Detection and Classification Proposal

David Abramson

Texas Instruments

July 2016 IEEE 802 Plenary, San Deigo, CA

Figure 104-4—PSE state diagram

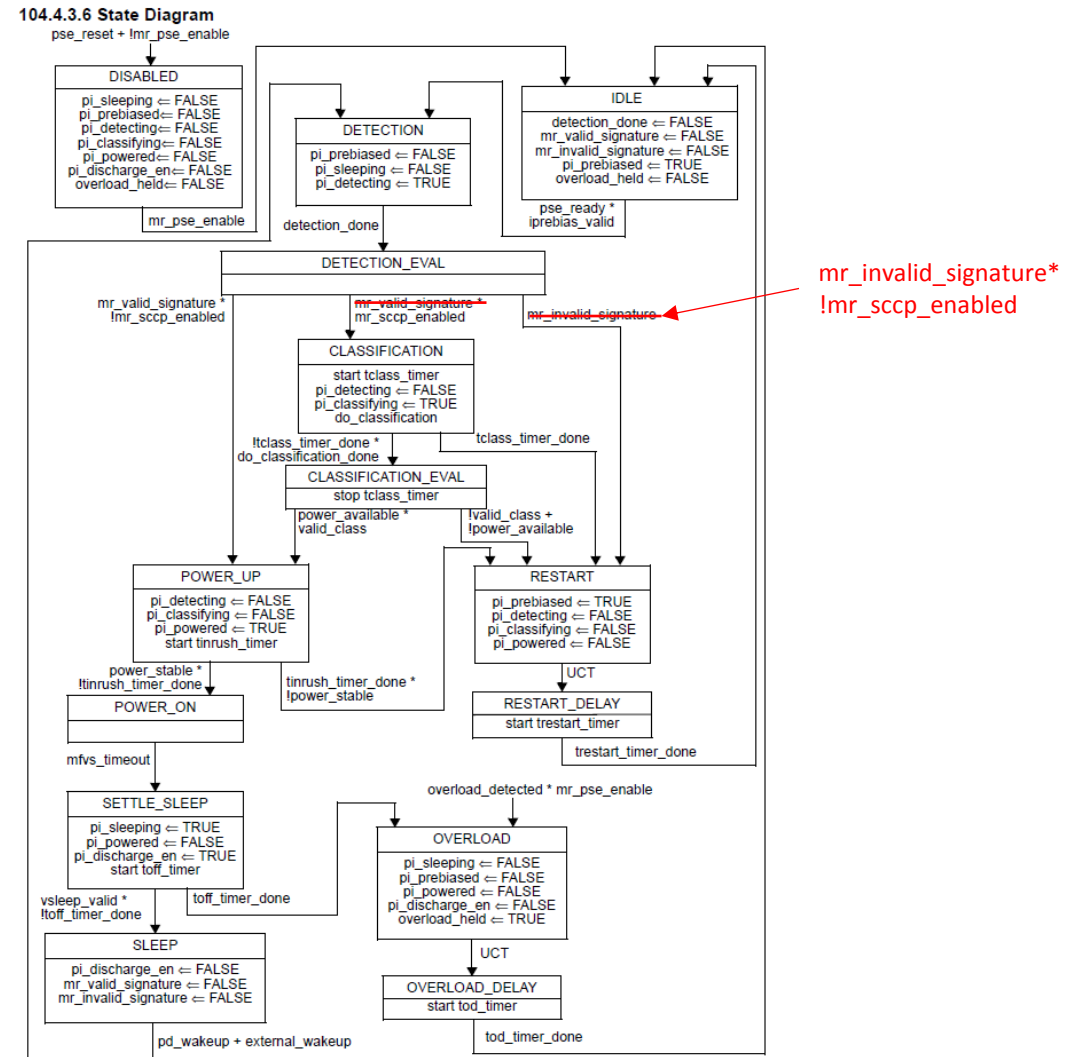
Proposed Changes to PSE SD

- PSEs that perform classification proceed to the CLASSIFICATION state regardless of the outcome of detection
- PSEs that can't perform classification are not allowed to power a PD with an invalid signature
- Editing Instruction: Make changes shown on right to Figure 104.4.3.6 (page 45, line 15)
